Re: Storage Unit Expansion, 4821 Central Avenue NW,
Traffic Circulation Layout,
Architect's Stamp dated 07-12-10 (K-11/D036)

Re: Storage Unit Expansion, 4821 Central Avenue NW,

Re: Storage Unit Expansion, 4821 Central Ave NW, Grading and Drainage Plan Engineer's Stamp dated 4-27-10 (K11/D036)

Re: Storage Unit Expansion, 4821 Central Ave NW, Grading and Drainage Plan Engineer's Stamp dated 4-27-10 (K11/D036)

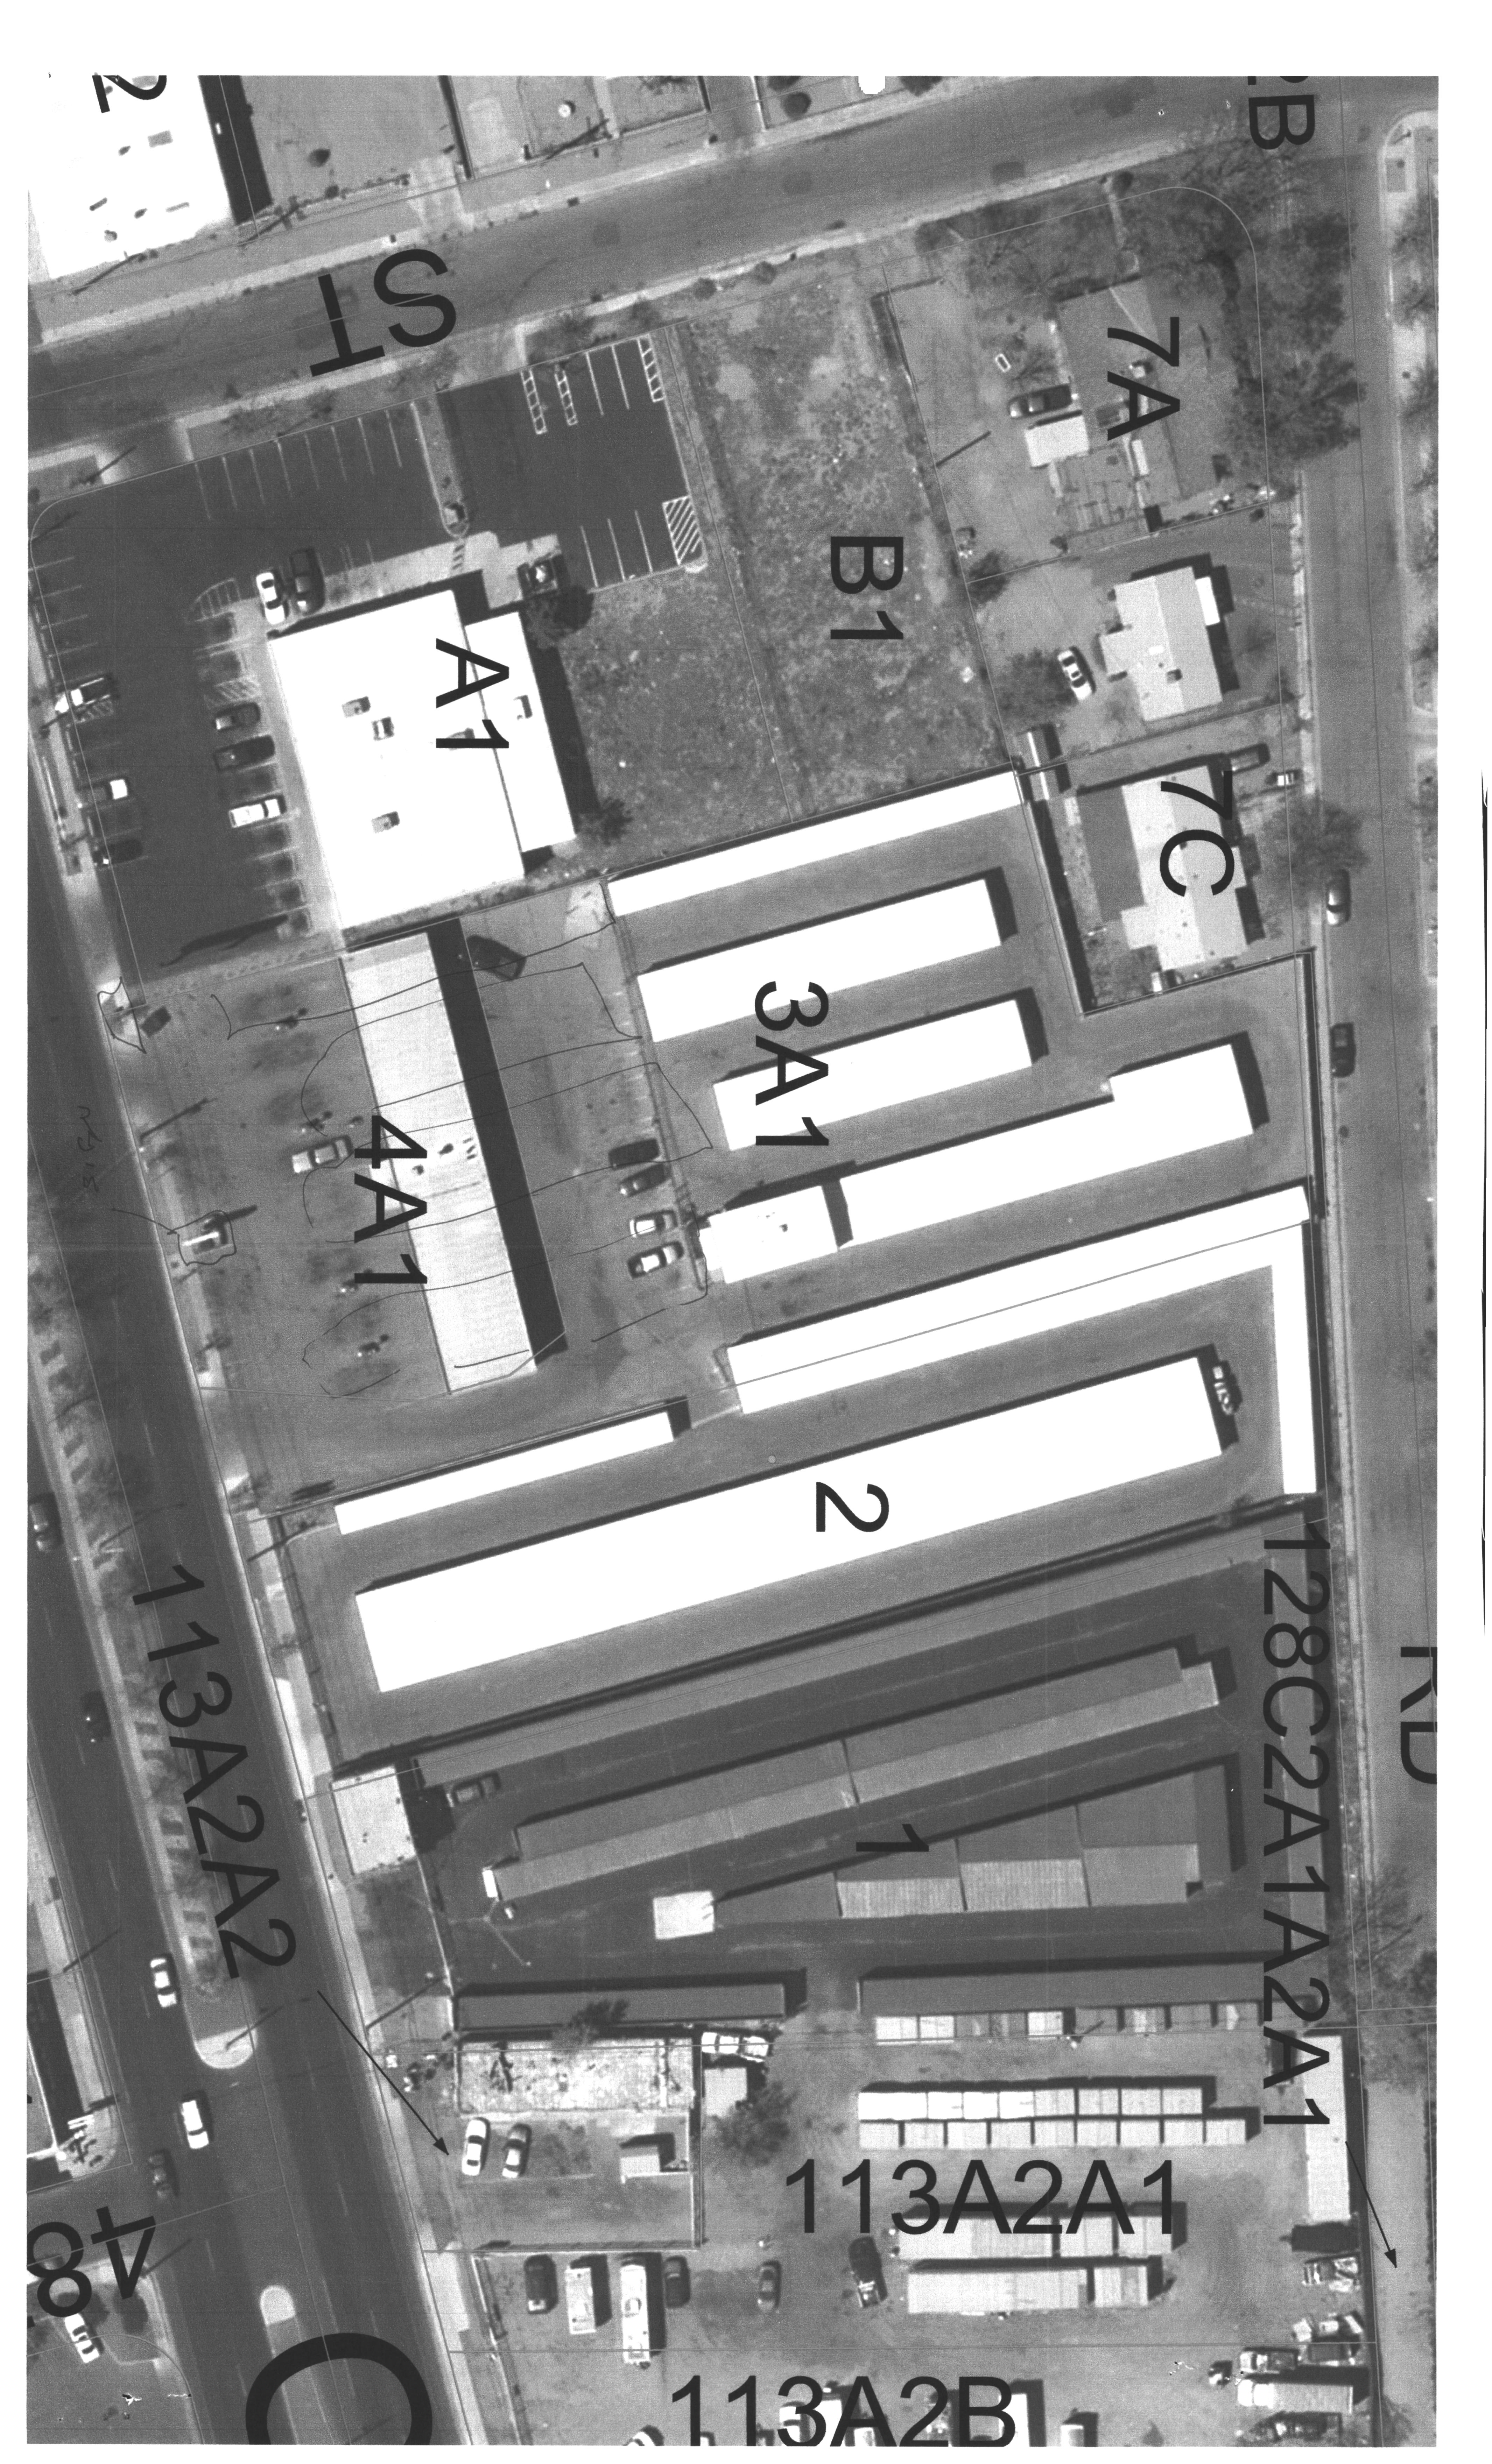
Laticinity MAR.

Dimension parking staces & East Drive (SEE fg. 3.7. IDPM) HANDICAPED

Legend. proud three Shading of Line

- Remove All information performing to etec., gos, transportation.

His of gate? Know Box?, when regardes open?

I to the offer the standard of the standard one our kend on the standard of t - what is the clear PAHH Dimension if Nehicles are parked on tast side of the Drive, for an Demonstrate How ingressing vehicles clear parked vehicles. - shadow the existing carmash, lives too busy. - Need: 43' cleer for ADA on MAN GATE. west gote > 25' flow line.

L" furn Around" @ ENTRANCE Demon STRATE, K-turn of 42' Needed,
